**ITB #2025-018906**

## **HOVLAND HALL WEST WING REMODEL CONSTRUCTION SERVICES**

### **ADDENDUM NO. 1**

OSU Hovland Dry Lab Remodel

A-601

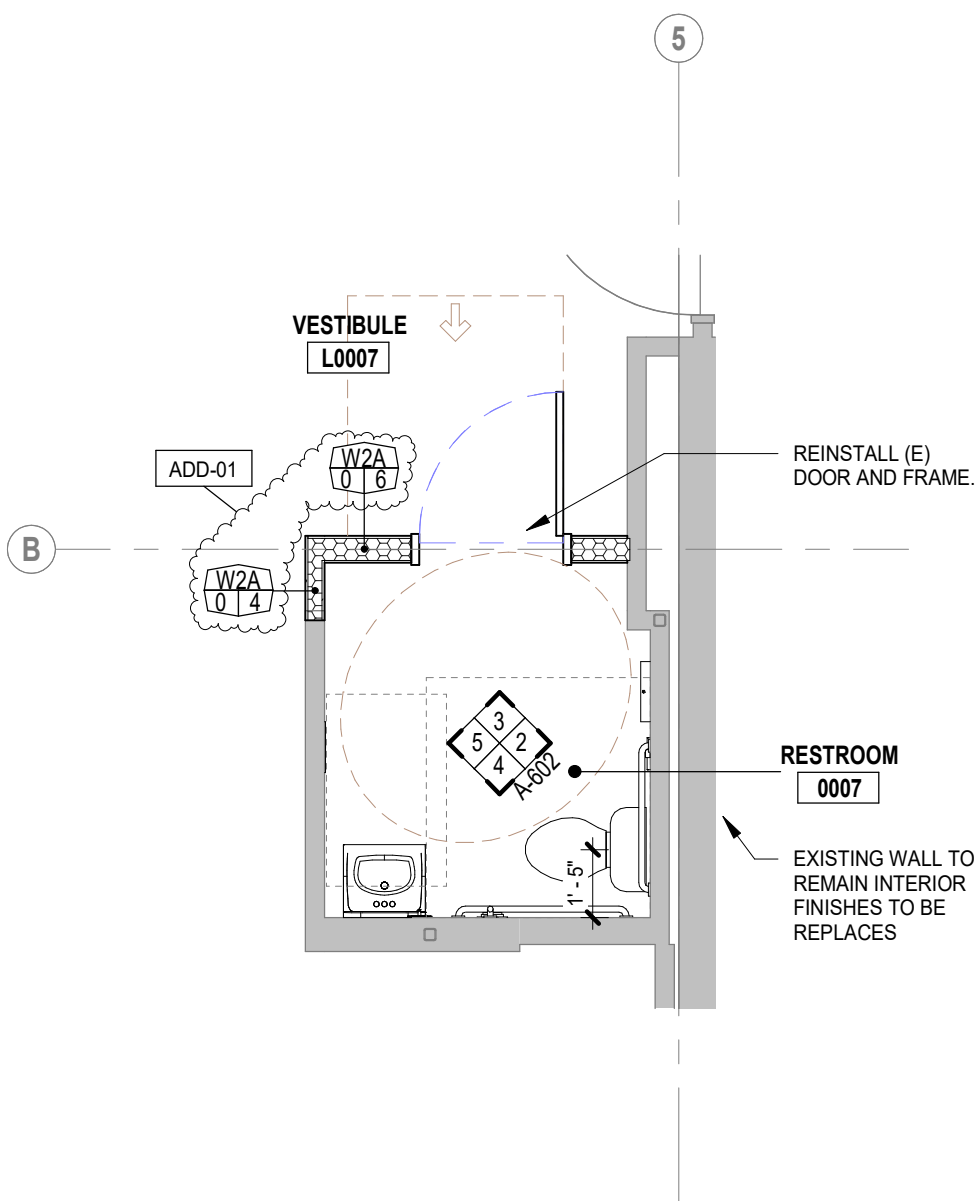
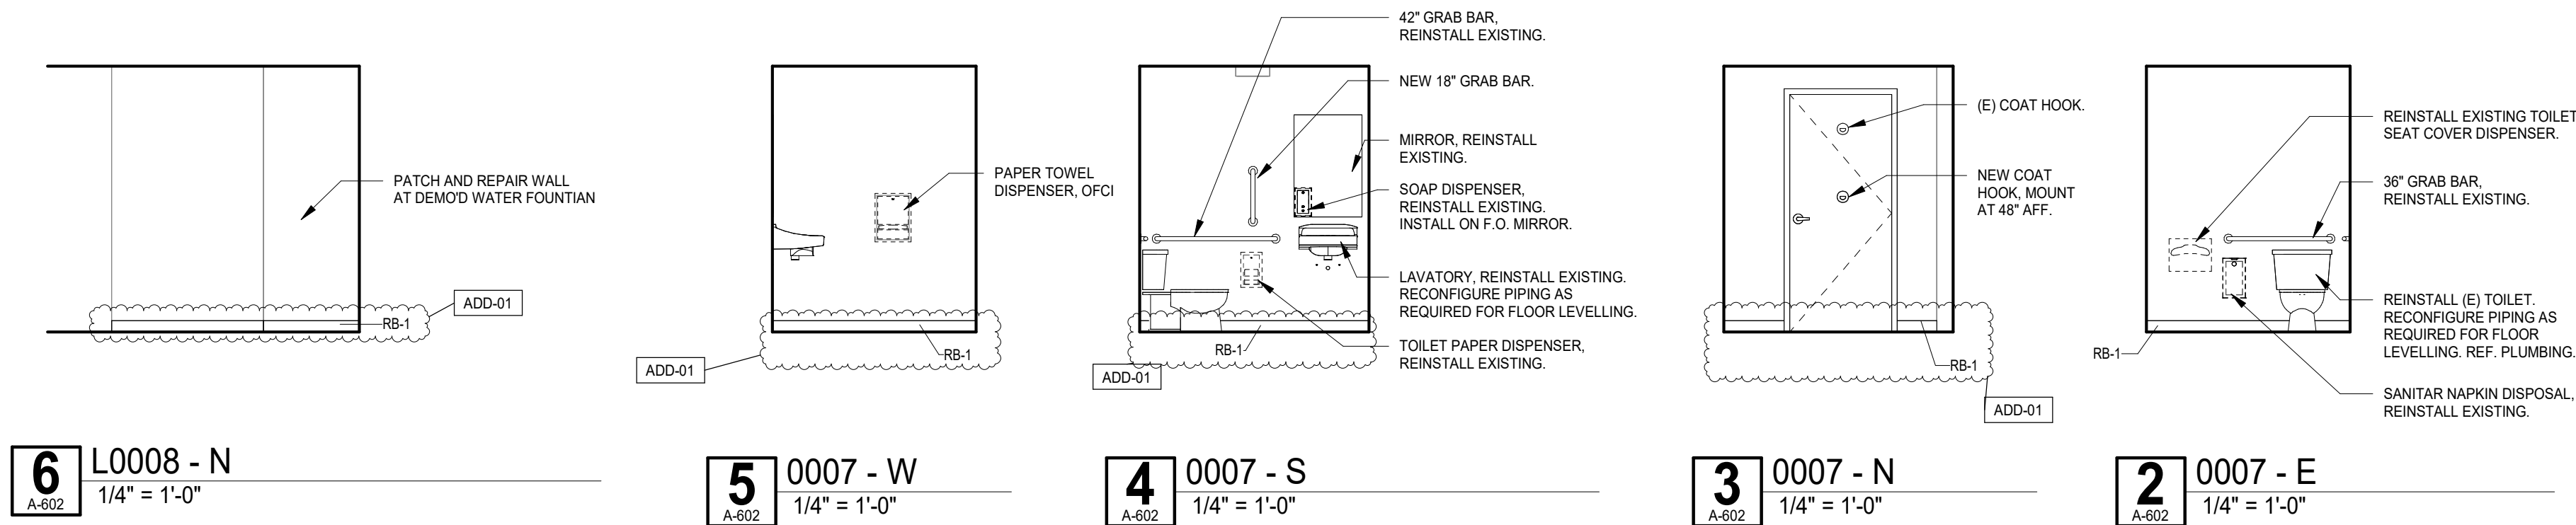
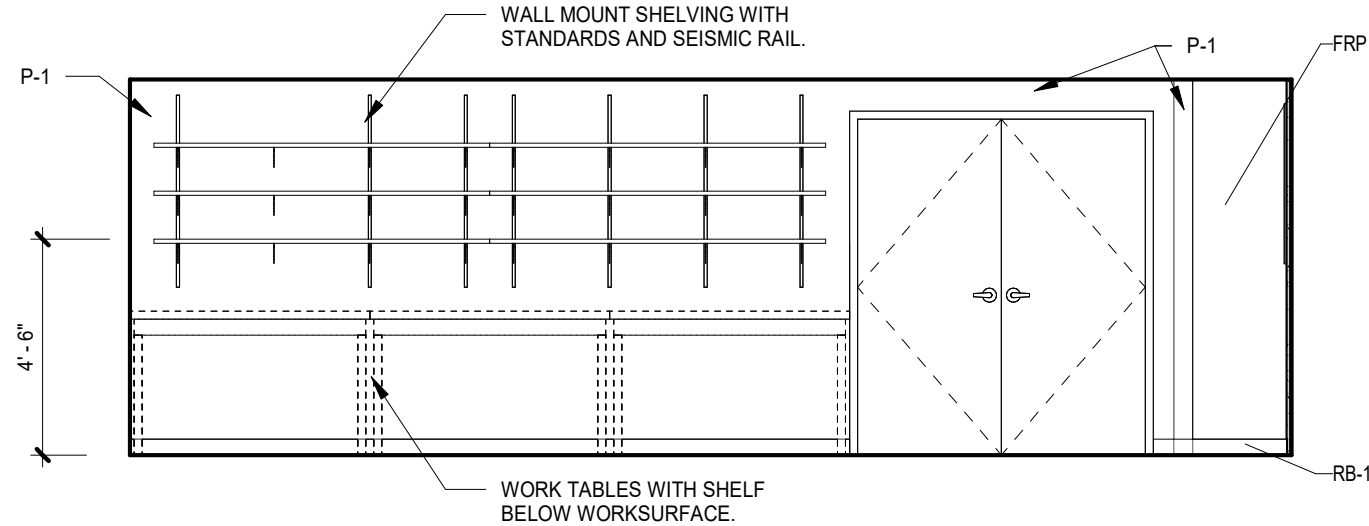
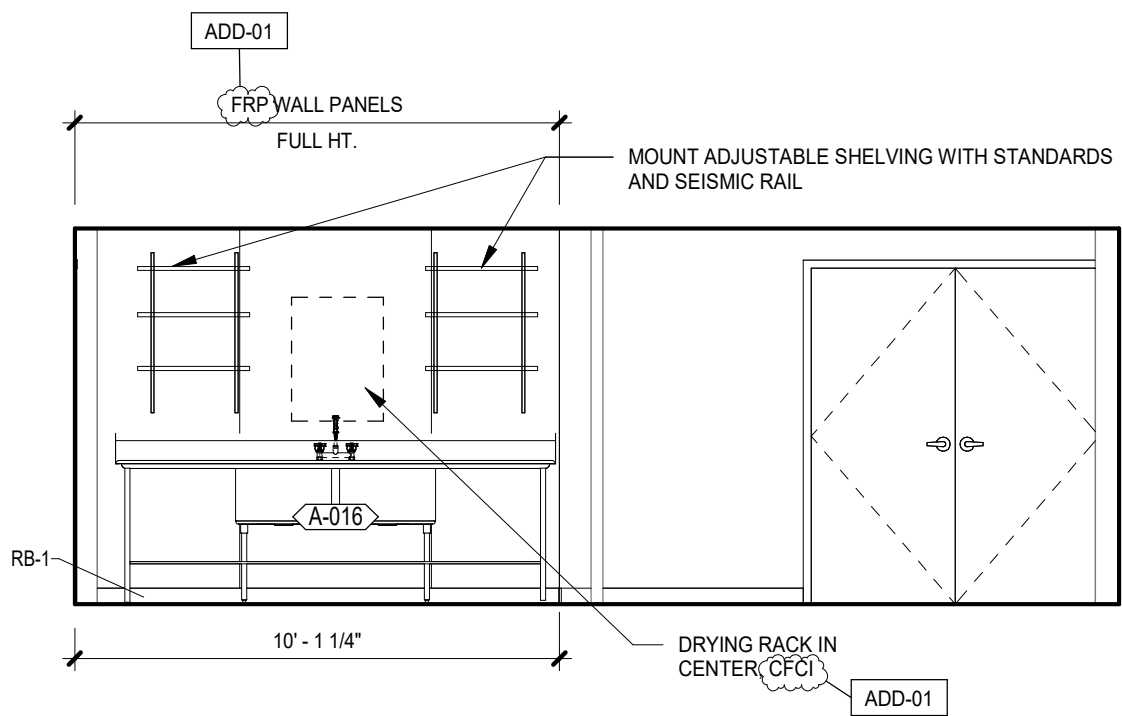
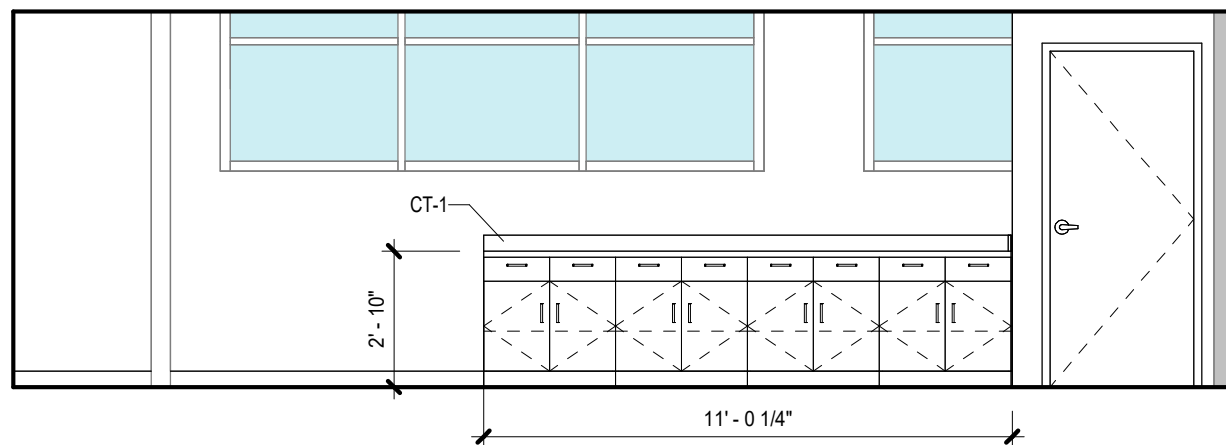
- 1) Sheet A-050 (re-issued, attached). Revisions include:
  - a) Demolition plan revised as shown.
  - b) Keynotes revised as shown.
- 2) Sheet A-111 (re-issued, attached). Revisions include:
  - a) Floor Plan revised as shown.
  - b) Reflected Ceiling Plan Revised as shown.
  - c) Floor Levelling + Concrete Pourback Plan revised as shown.
  - d) Keynotes revised as shown.
- 3) Sheet A-301 (re-issued, attached). Revisions include:
  - a) Detail # 2 revised as shown.
- 4) Sheet A-501 (re-issued, attached). Revisions include:
  - a) Door schedule and notes revised as shown.
- 5) Sheet A-601 (re-issued, attached). Revisions include:
  - a) Elevation 1 revised as shown.
  - b) Keynotes revised as shown.
- 6) Sheet A-602 (re-issued, attached). Revisions include:
  - a) Elevations 2-6 revised as shown.
  - b) Enlarged Plan revised as shown.

| Key Value | Note  |
|-----------|---|
| A-003     | SOLDERING STATION EXHAUST SNORKEL. REFERENCE MECHANICAL ATTACH TO BLOCKING AT (E) STRUCTURE ABOVE. PROVIDE (2) 2X4 BLOCKS (W/ SIMPSON HUC44 EA. END TO (E) JOISTS) TYPICAL. ADD-01        |
| A-016     | STAINLESS STEEL CUSTOM SINK FULLY WELDED, WITH BACKSPLASH, 2 DRAIN BOARDS AND 2 BASINS. 1 FAUCET, INCLUDE INTEGRATED SHELF FULL LENGTH BELOW BASINS AND DRAINBOARDS. REF PLUMBING. ADD-01 |

A-701

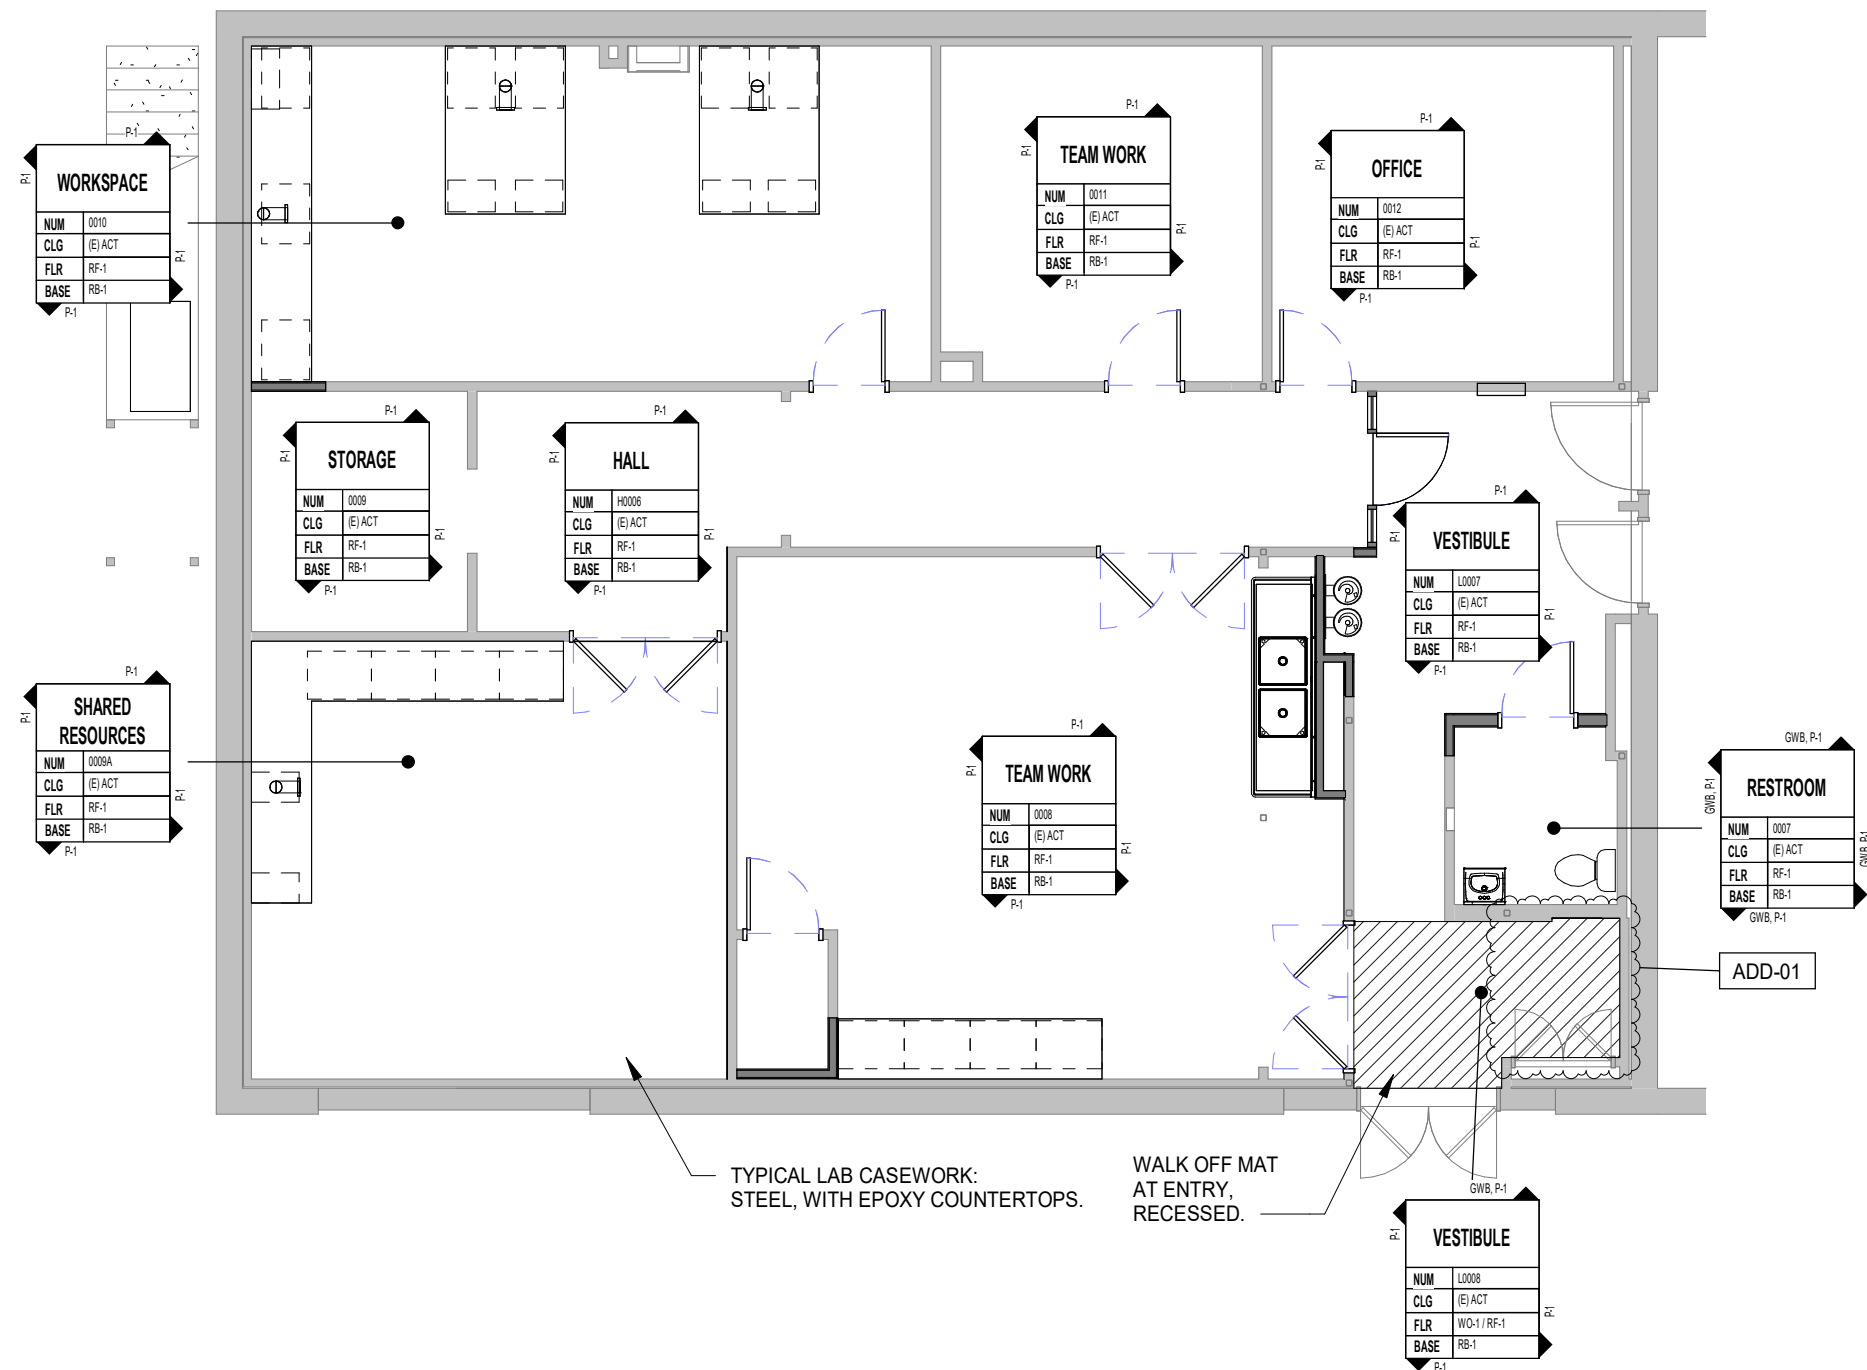
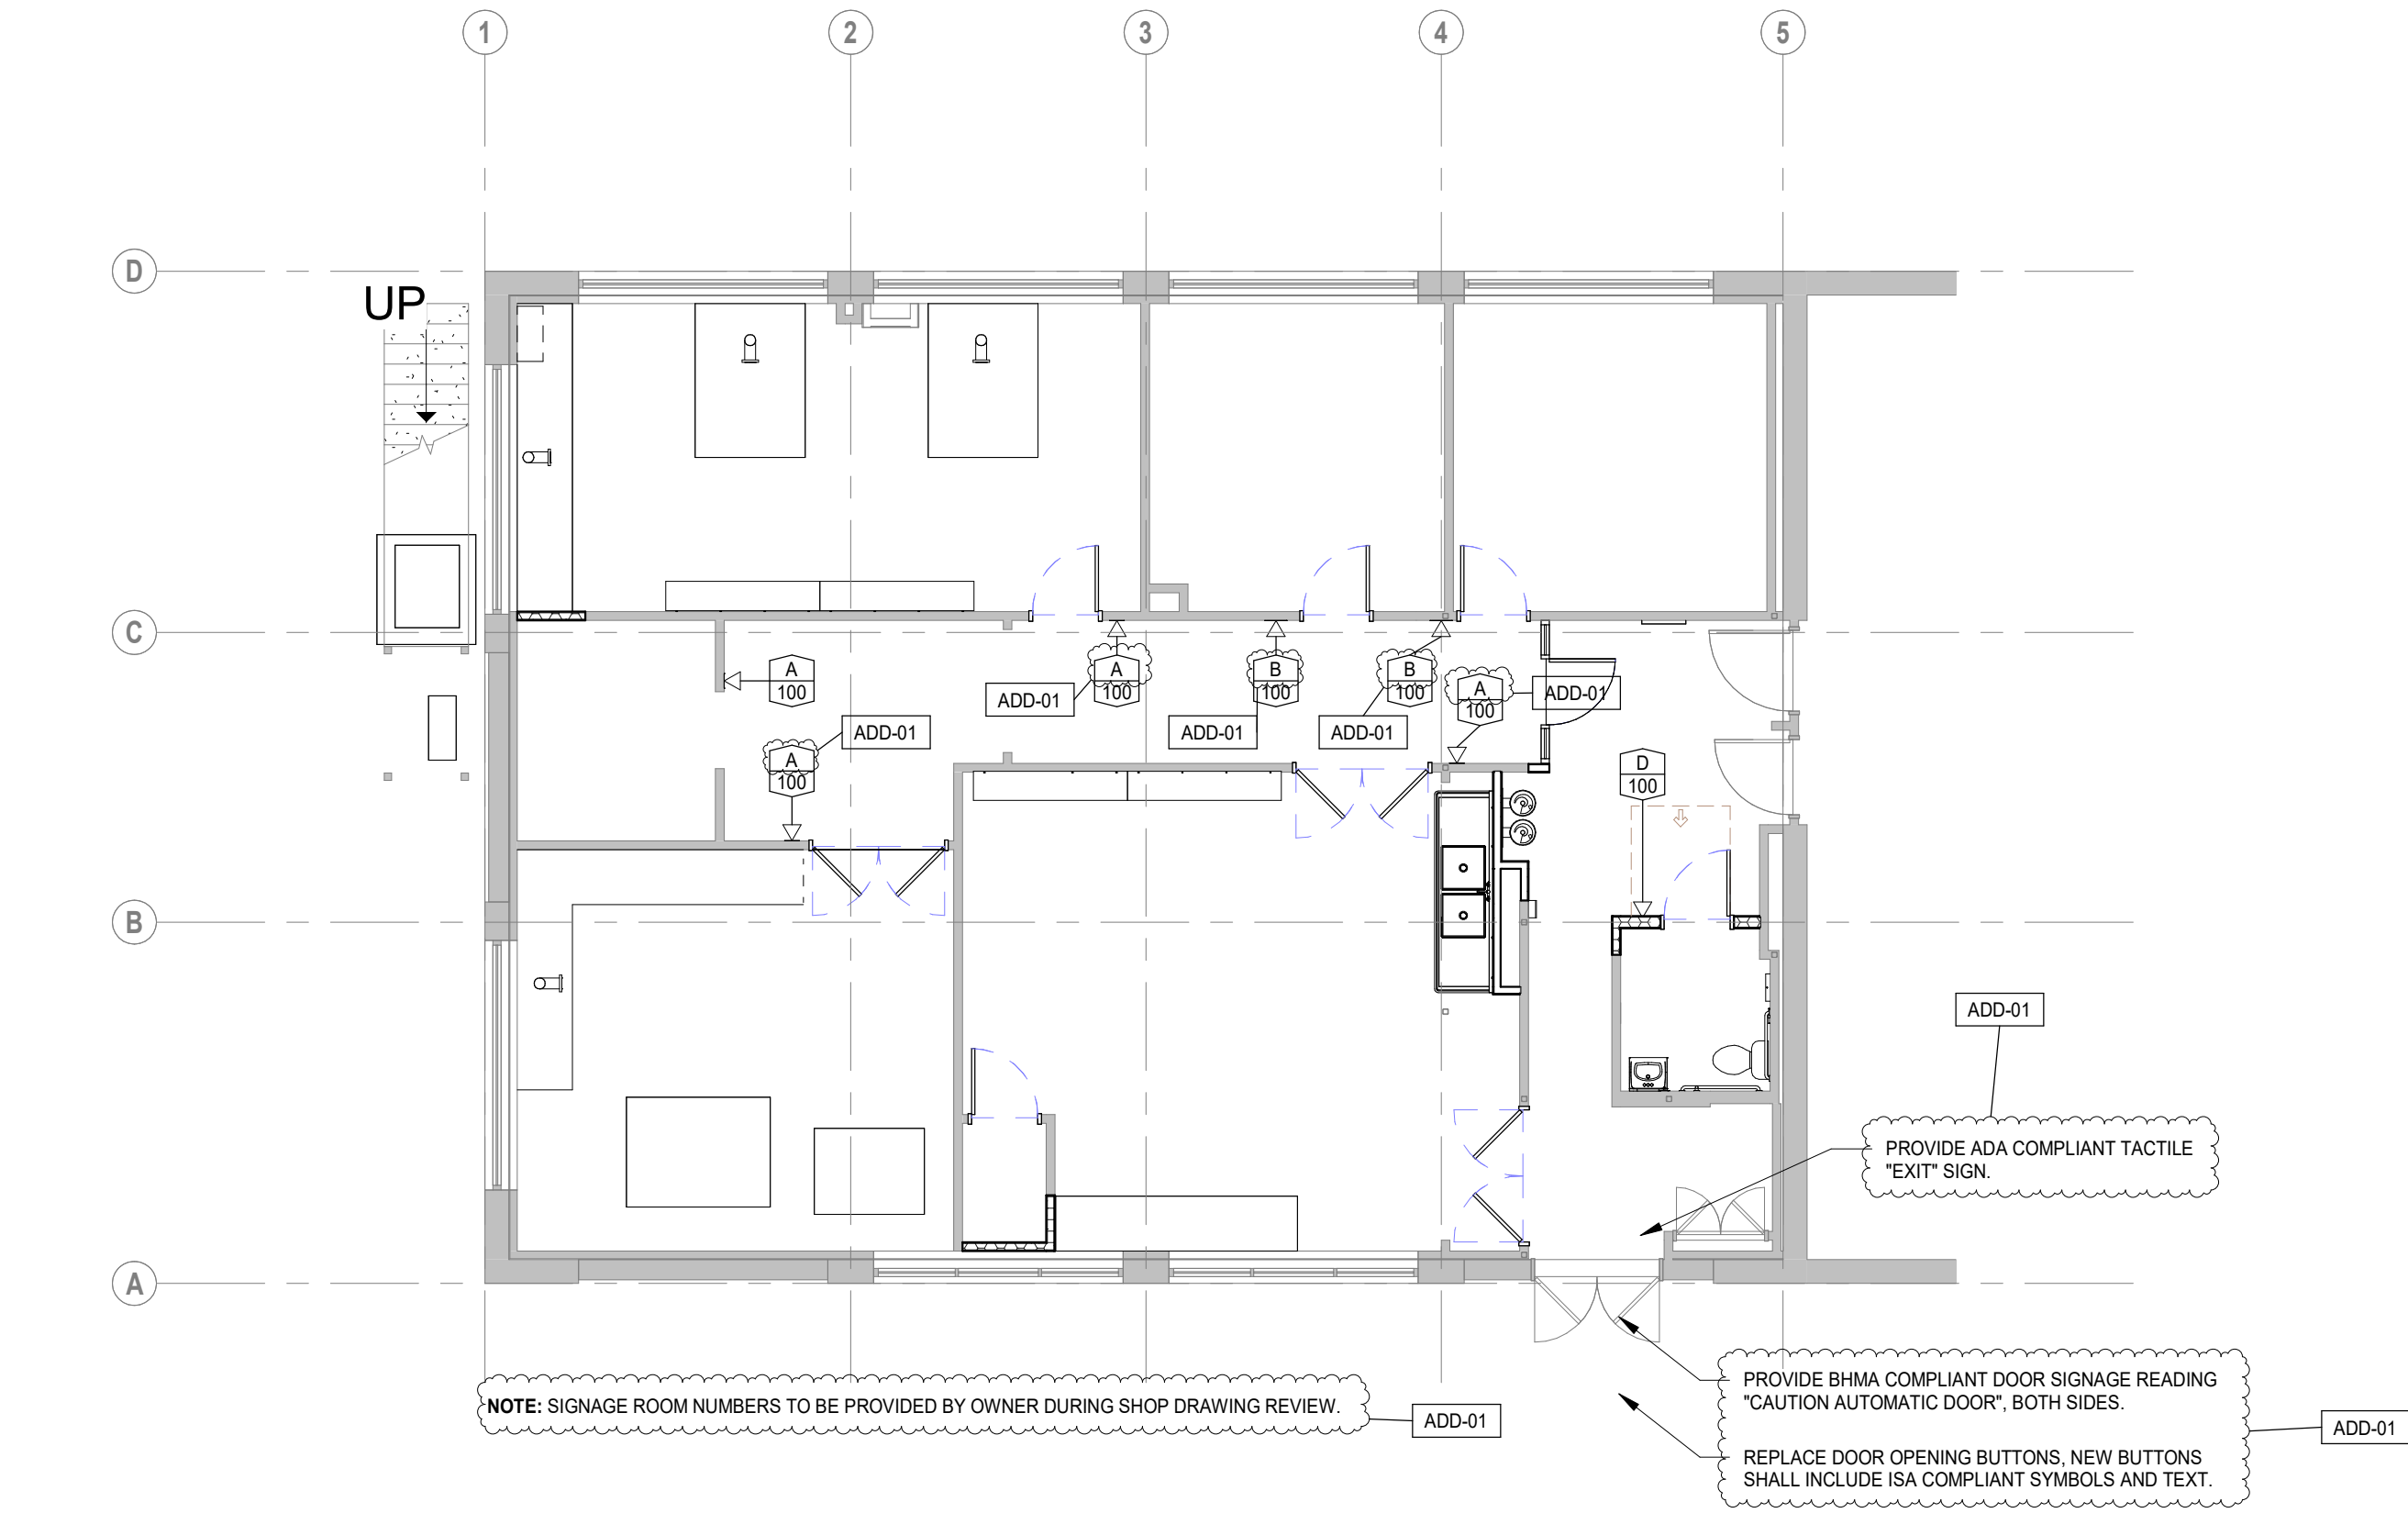
- 7) Sheet A-701 (re-issued, attached). Revisions include:
  - a) Finish Legend Revised as shown.
  - b) Finish Plan revised as shown.
- 8) Sheet A-900 (re-issued, attached). Revisions include:
  - a) Signage Plan revised as shown.
- 9) Sheet M-201 (re-issued, attached). Revisions include:
  - a) Level 1 Mechanical Plan revised as shown.
  - b) Roof Plan added.
  - c) Sheet Keynotes revised as shown.
- 10) Sheet A-300 (re-issued, attached). Revisions include:
  - a) Exhaust snorkel detail added.
